CITY OF ALBUQUERQUE

RE: **Lot 11 Block 3 S.A.D. 227 Unit 2**
5605 Kimberlite Dr. NW
Grading and Drainage Plan
Engineers Stamp Date 6/7/2021 (E10D106)

DRAINAGE AND TRANSPORTATION INFORMATION SHEET (REV 6/2018)

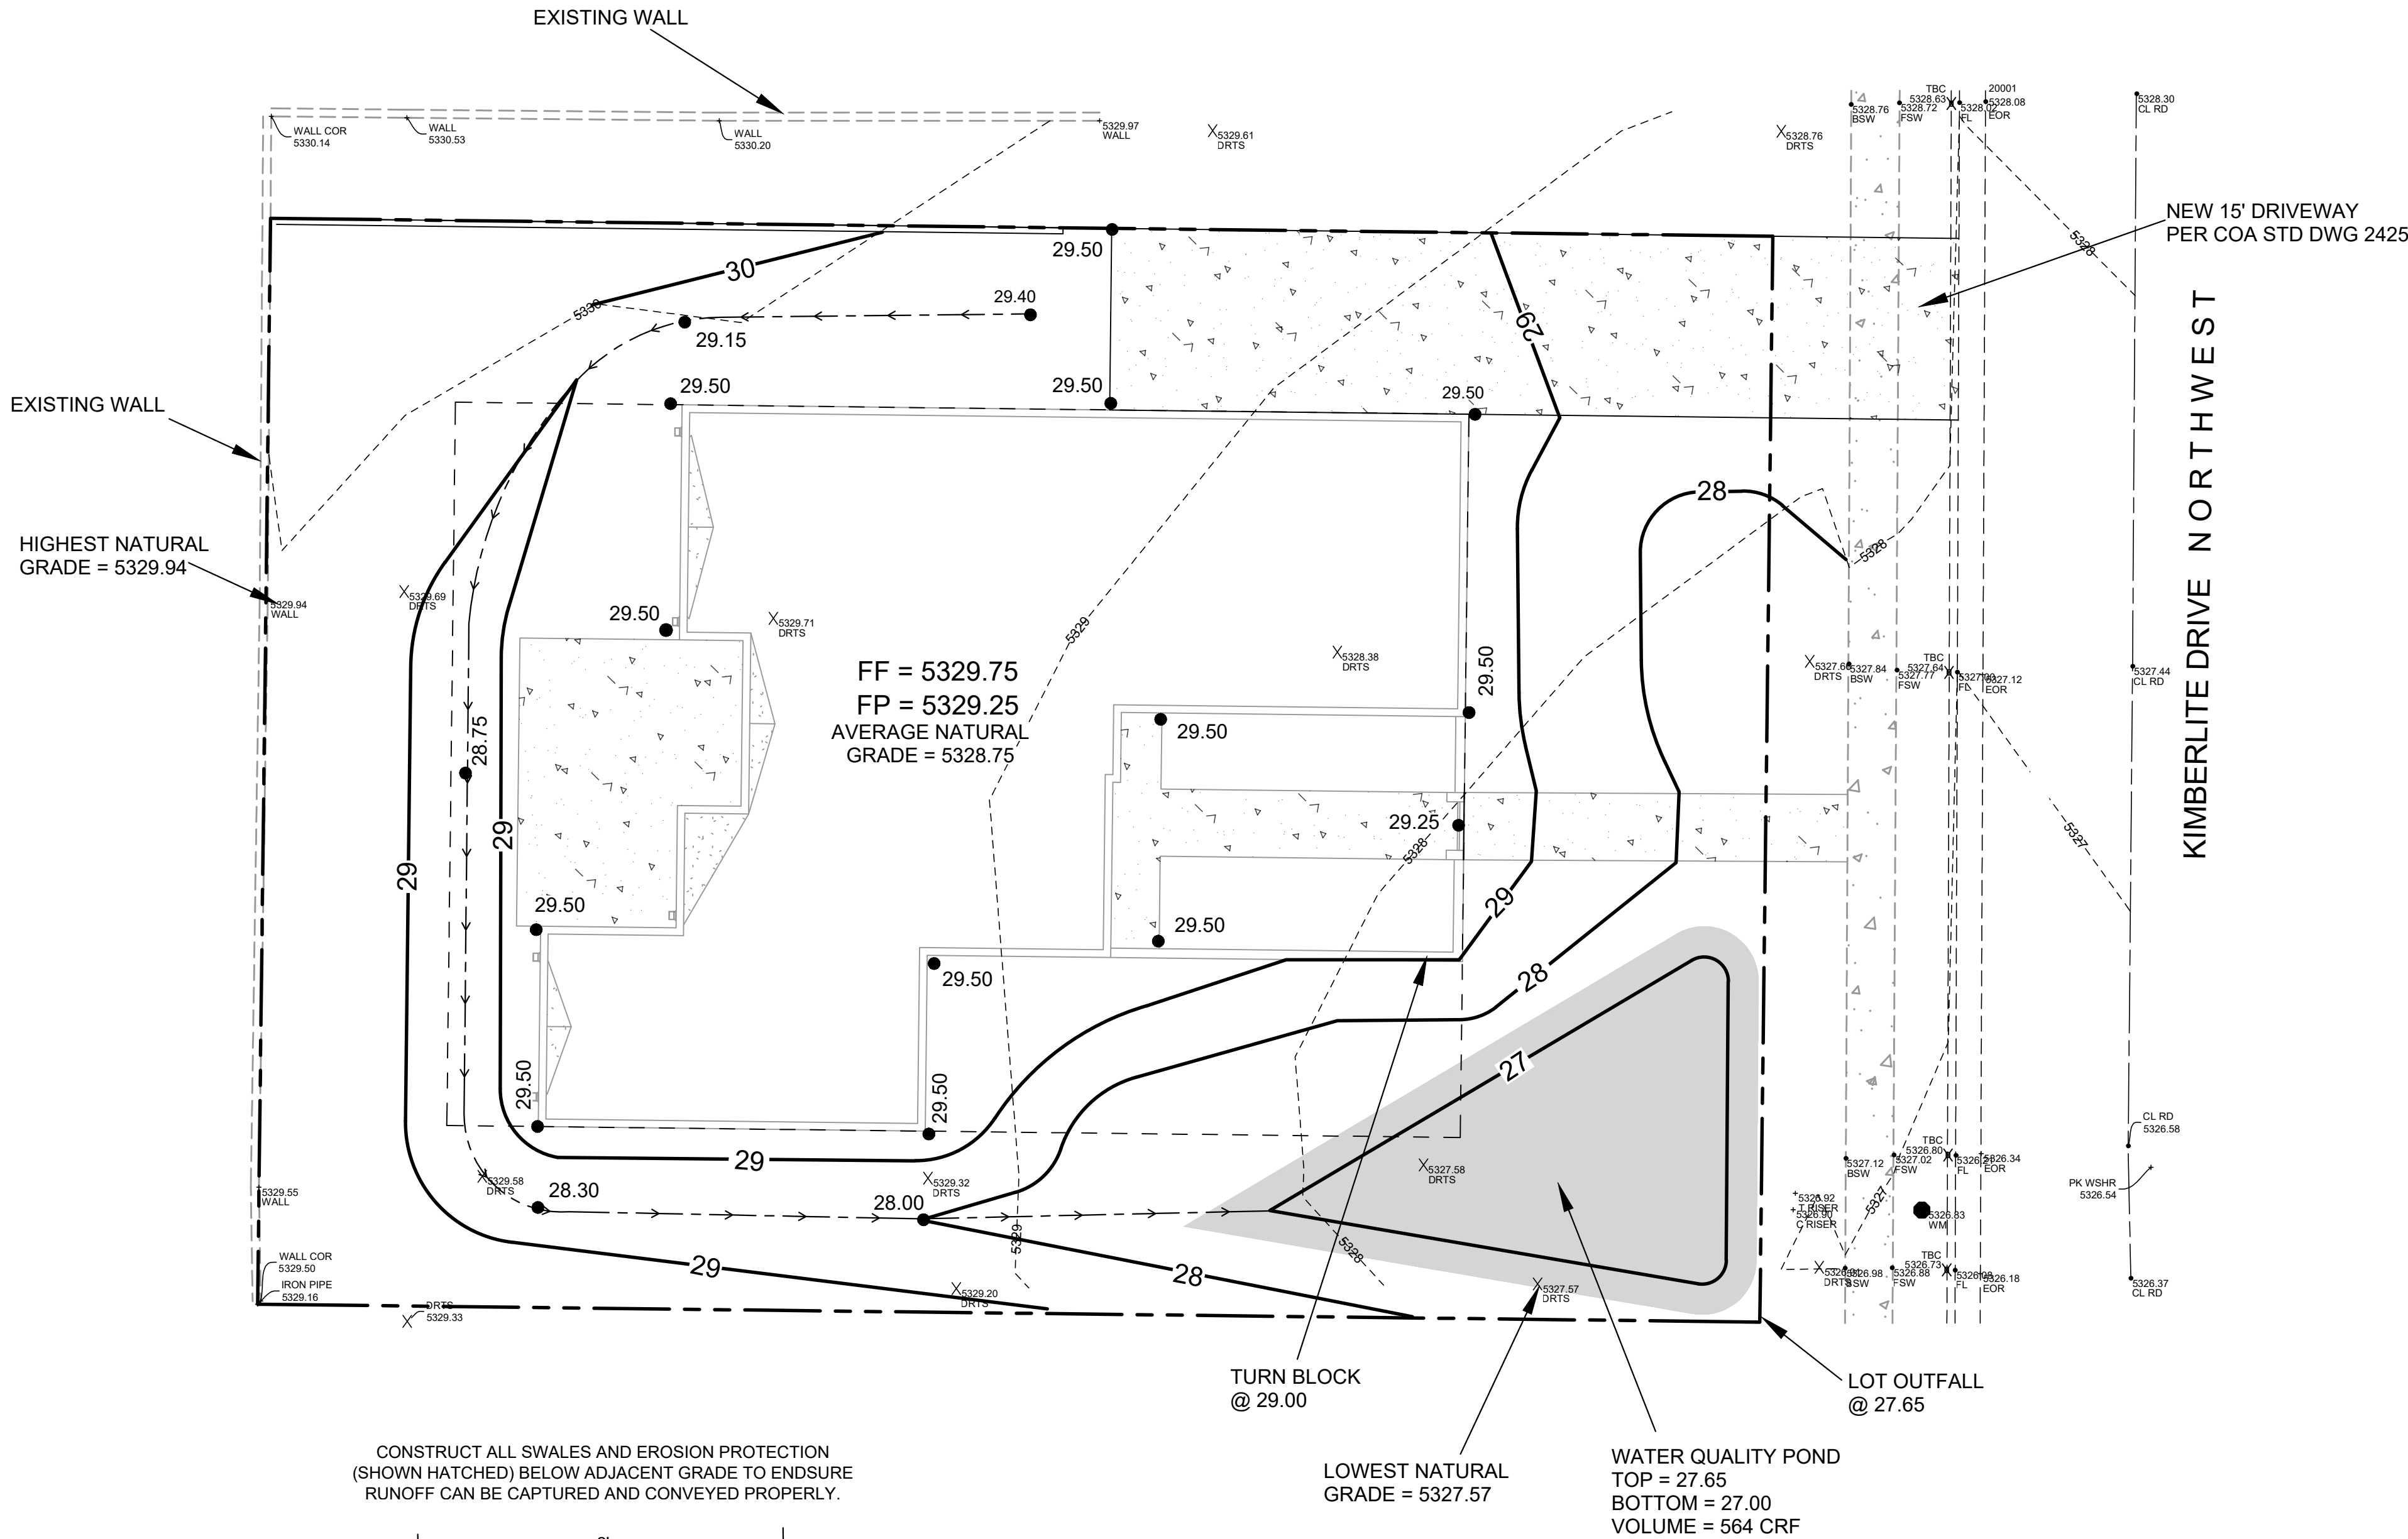
Based upon the information provided in your submittal received 6/89/2021, this plan is approved for Grading Permit. Please inform the builder/owner to attach a copy of this approved plan and letter into the construction sets in the permitting process prior to sign-off by Hydrology.

Reiterate to the Owner/Contractor that a separate permit for any garden/retaining wall must be obtained, with the approved G&D plan. Advise the owner contractor not to use dirt as a ramp to climb the curb, use lumber or crusher fines for this purpose. Also, let the owner/contractor know that if a pool is to be added in the future the G&D plan will need to be modified showing the location of the pool and the land treatment differences.

Prior to Building Permit approval, a **Pad Certification** will be required. Inform the contractor/owner not to pile dirt in the street as a ramp to climb the curb. If dirt is found in the street the pad cert. will be denied.

Prior to **Certificate of Occupancy release**, Engineer Certification per the DPM checklist of this plan will be required.
